**TOWN OF NEWBURGH  
PLANNING BOARD  
TECHNICAL REVIEW COMMENTS**

**PROJECT NAME:** ATHBOY ROAD 4-LOT SUBDIVISION  
**PROJECT NO.:** 24-36  
**PROJECT LOCATION:** SECTION 8, BLOCK 1, LOT 105  
**REVIEW DATE:** 9 JULY 2025  
**MEETING DATE:** 17 JULY 2025  
**PROJECT REPRESENTATIVE:** CM TERRIZZI ENGINEERING, PLLC

ENGINEER	C.M. TERRIZZI ENGINEERING, PLLC 11 TERRIZZI DR. WALKILL, N.Y. 12589 (845) 239-2020	
	PROPOSED GRADING & SEPTICS	
	SUBDIVISION FOR: SANSTORM HOLDING INC S.B.L.: 8-1-105 / ATHBOY RD / 19.10 ACRES TOWN OF NEWBURGH, ORANGE COUNTY, NY	
DATE 5/20/2025	SCALE 1" = 60'	SHEET NUMBER 2 OF 7

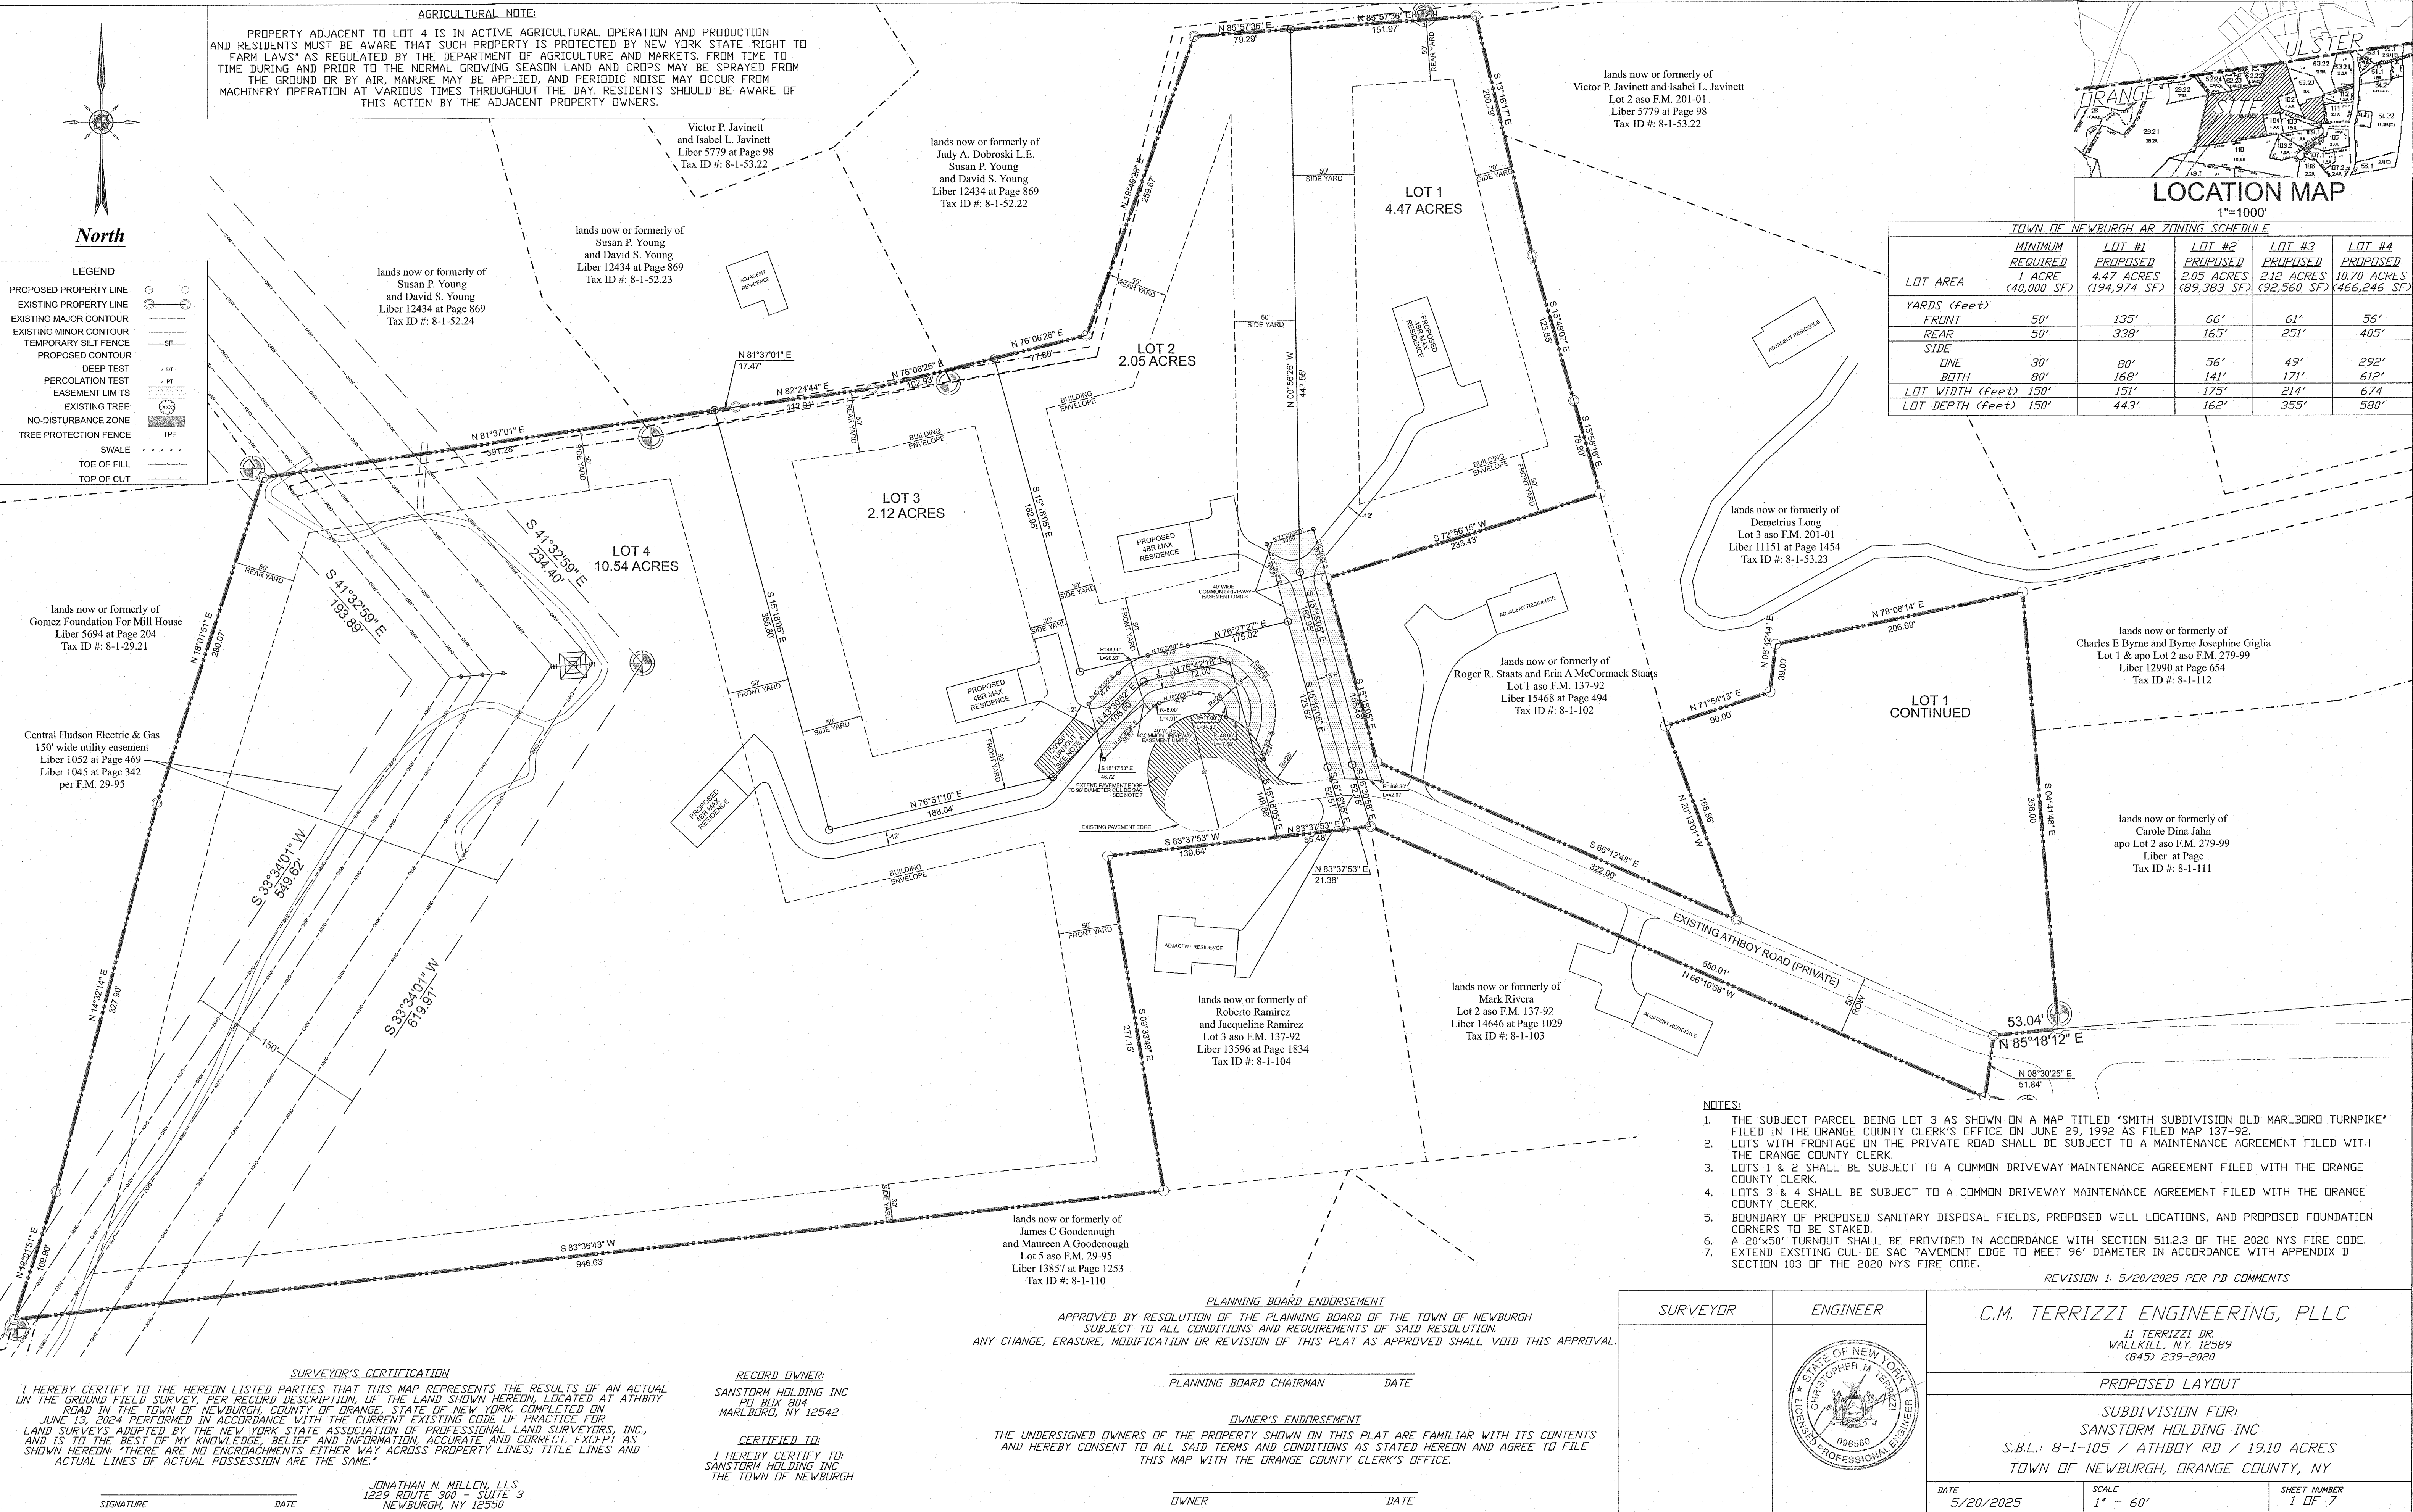
1. The Orange County Planning Department issued a local determination on 7 June 2025.
2. On 1 July 2025, this office submitted the project to the Town of Marlborough and the Town of Marlborough Planning Board.
3. Notes must be added to the subdivision plan regarding construction timeframe restrictions for mitigation regarding Bald Eagles as identified by the New York State Department of Conservation.
4. A Construction Stormwater Permit from the New York State Department of Environmental Conservation is required.
5. Compliance with the Town's Tree Preservation Ordinance has been documented.
6. Driveway Access and Maintenance Agreement are required.
7. A Public Hearing is required.
